South Texas Project Electric Generating Station P.O. Box 289 Wadsworth, Texas 77483

February 10, 2006
NOC-AE-06001969
10CFR50.36
10CFR50.90

South Texas Project
Units 1 and 2
Docket Nos. STN 50-498, STN 50-499
Response to NRC Requests for Additional Information on
STPNOC Proposed Risk-Informed Technical Specifications

**Response to NRC Request for Additional
Information dated July 14, 2004**

Comparison of Planned and Actual Risk (ICCDP) for Unit 2 During SDG 22 Outage

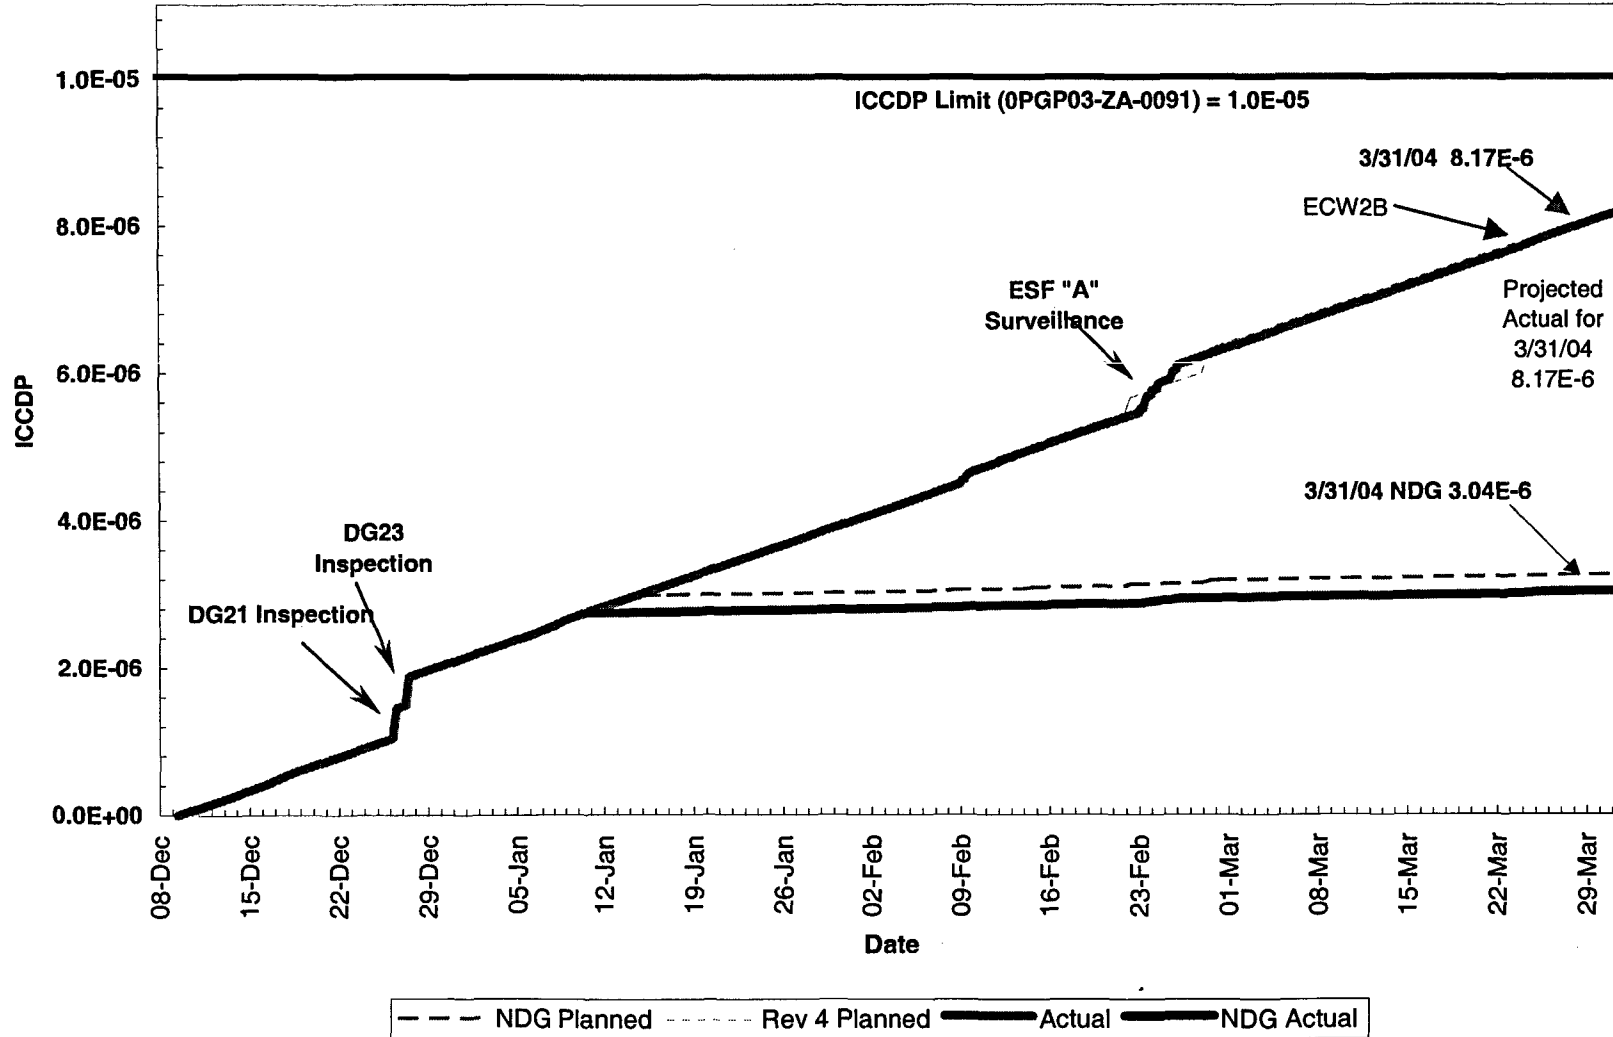
21. **The staff has been granting SDG AOT extensions up to 14 days provided the licensees have installed an extra A.C. power source or make available the alternate A.C. source installed to satisfy the requirements of station blackout rule. This extra power source can be substituted for an inoperable SDG during the extended AOT. Additionally, these requests are supported by a PRA analysis that demonstrates that overall risk is very low during the extended outage. In view of the above, provide justification for extending the AOT beyond 14 days without an extra power source.**

STPNOC performed extensive evaluations to justify the one-time extension of the allowed outage time for SDG-22 (Unit 2, Train B) to 113 days. Although STPNOC installed temporary diesel generators as a compensatory action, the actual configuration risk for the SDG-22 extended outage without crediting the temporary diesel generators was less than 1E-05 (see attached figure).
